Service Bulletin

Bulletin No.: 21-NA-260

Subject: Lack of Power or Poor Performance During High Ambient Temperatures with RPO (C7N) 12,300 LB GVWR or (C4M) 9,900 LB GVWR

Brand:	Model:	Model Year:		VIN:		Engine:	Transmission:
		from	to	from	to		
Chevrolet	Express	2016	2020			6.0L, L96 LC8	All
GMC	Savana

5923357

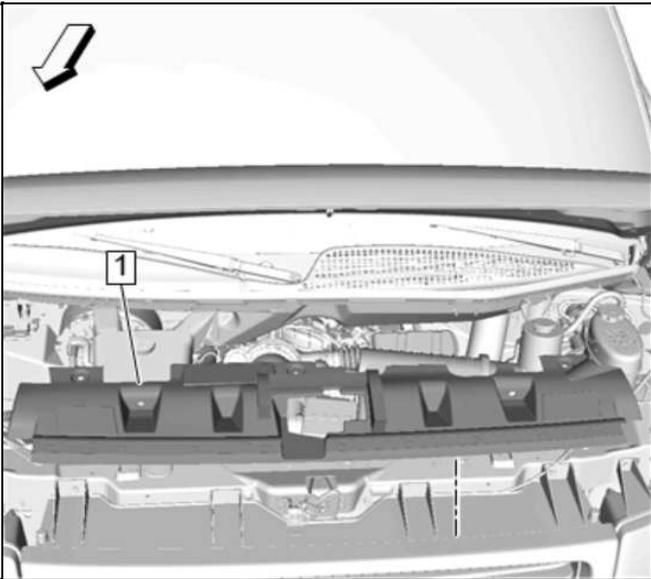
- Is the hood seal installed (1) ?
- Are both CRFM side baffles, driver and passenger side, installed correctly (2) ?
- Are both grille seals installed correctly (3) ?
- Is the hood latch seal installed correctly (4) ?
- Is the radiator upper baffle installed correctly (5) ?
- Is the lower baffle installed correctly (6) ?
- Is the air box end cover installed properly ?
- Are all intake air ducts installed correctly and clamps tight ?
- Is the PCV hose installed correctly ?
- Is the air box attached to upper tie bar with correct fasteners and secure ?
- Has the up-fitter installed components in front of the grille, blocking fresh air flow to CRFM ?
- Has the up-fitter modified anything to attach their components ? (Baffles, fascia, hood seal or anything else)
- Are there any holes cut/drilled in any sheet metal near the AIS inlet ?
- Inspect the intake duct for any restrictions.

4847540

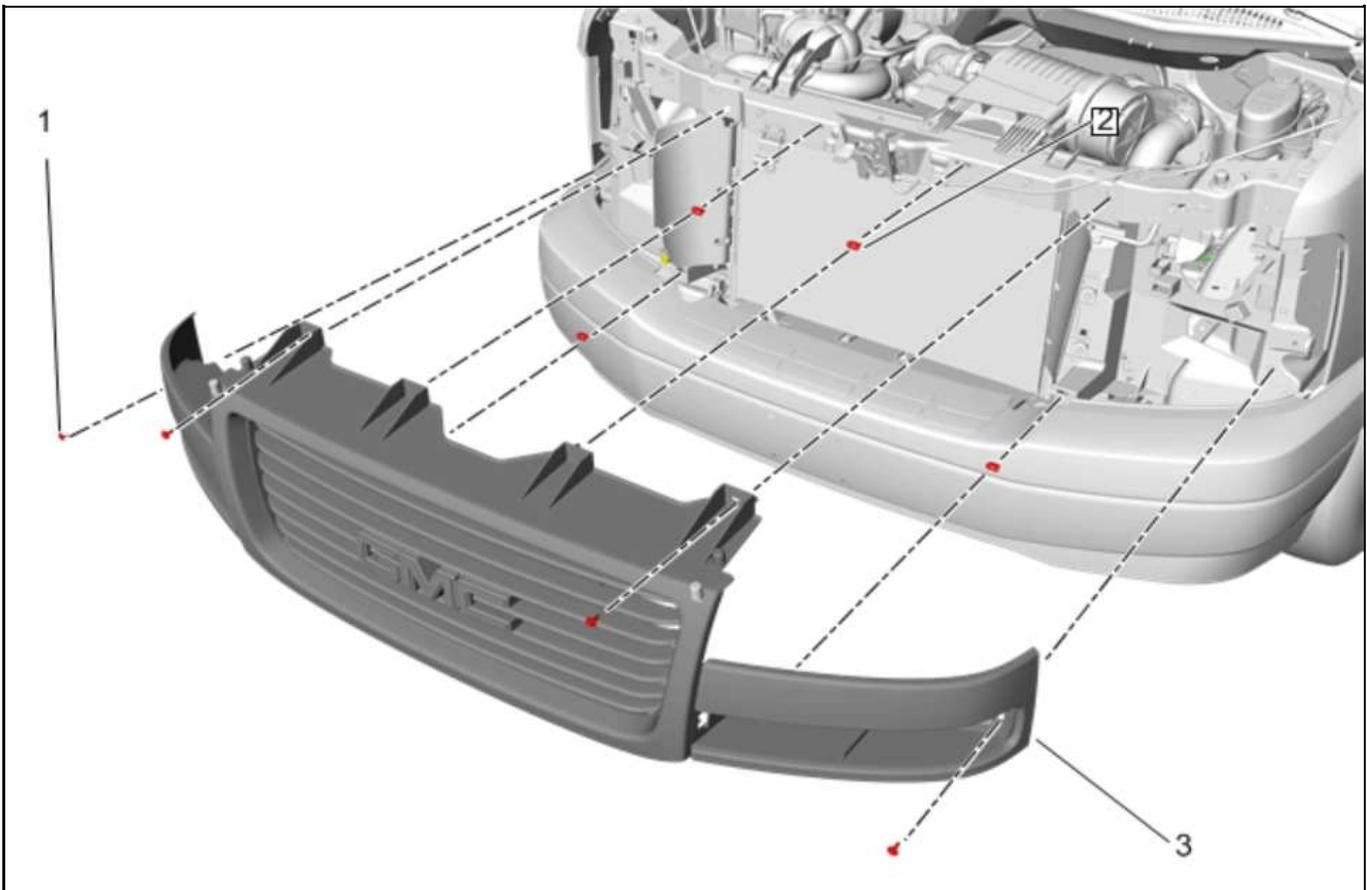
1. Remove the radiator air upper baffle (1). Refer to the appropriate *Radiator Air Upper Baffle Replacement*, in SI.

4839923

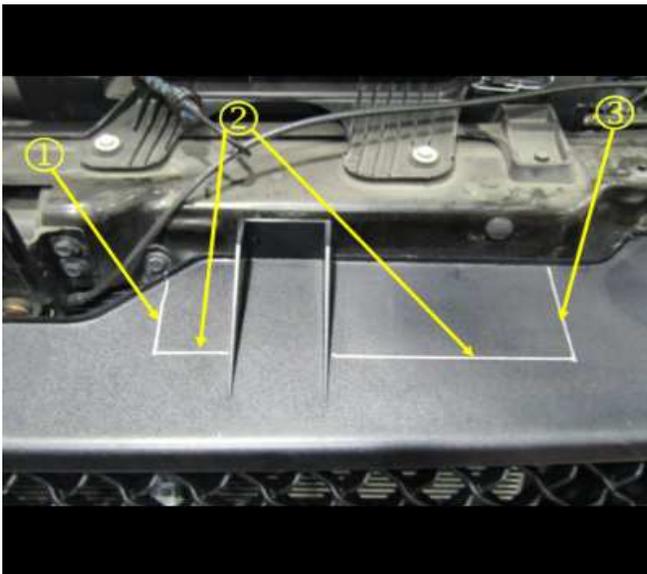
2. Remove the 4 front grille upper bolts (1). Refer to the appropriate *Front Grille Replacement* in SI.
3. Using a grease marking pencil, or suitable marker, mark the locations for removal of grille material, following the steps below:

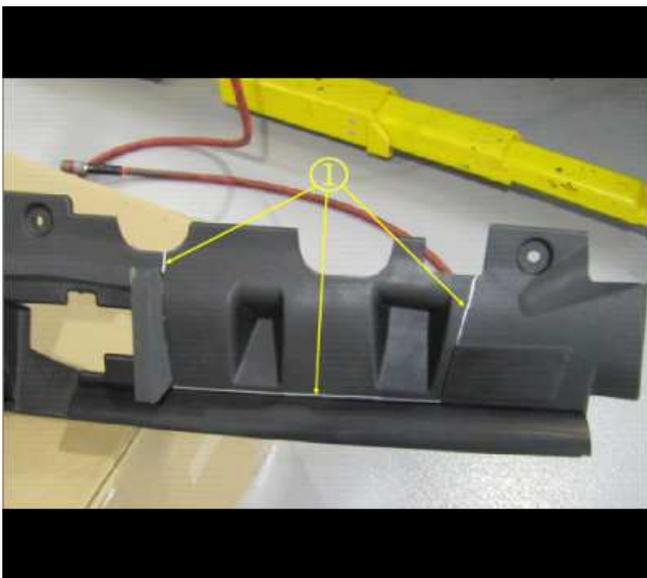
4. Using a suitable saw, cut along edges of the standing ribs and the marked lines.

5. The grille will now have openings on either side of the standing ribs.

5923335

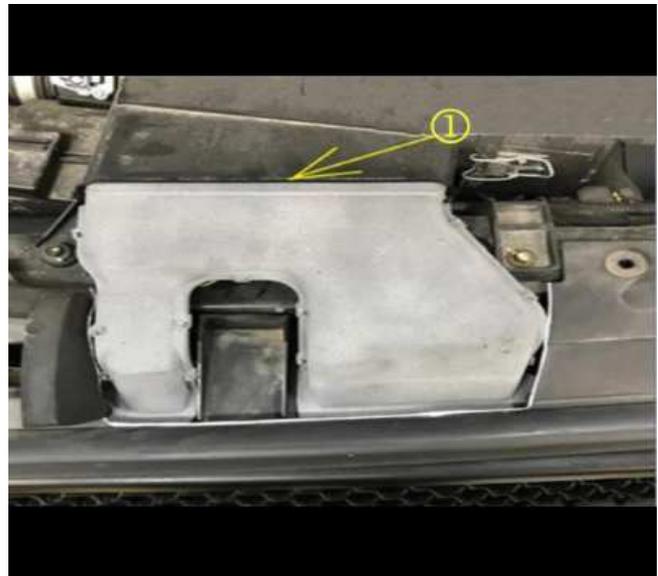
8. Using a suitable saw, cut along the marked lines.

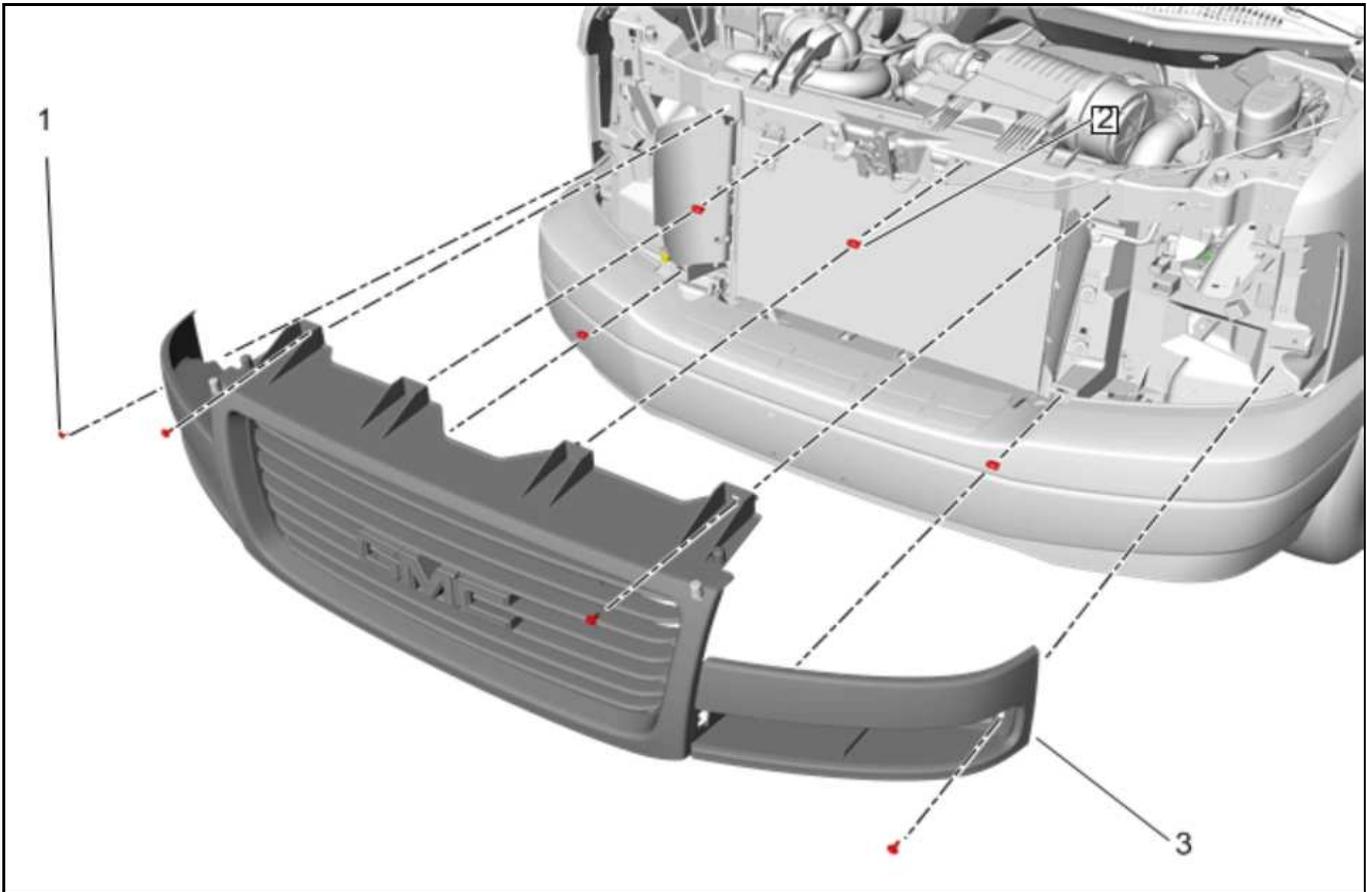
Note: The RTV sealant is to be applied onto the extended lip, around the perimeter of the upper opening of the engine air inlet duct, where it interfaces (1) with the opening of the intake duct.

9. Apply RTV Engine sealant around the complete perimeter of the upper opening of the engine air inlet duct, at the interface to the intake duct.
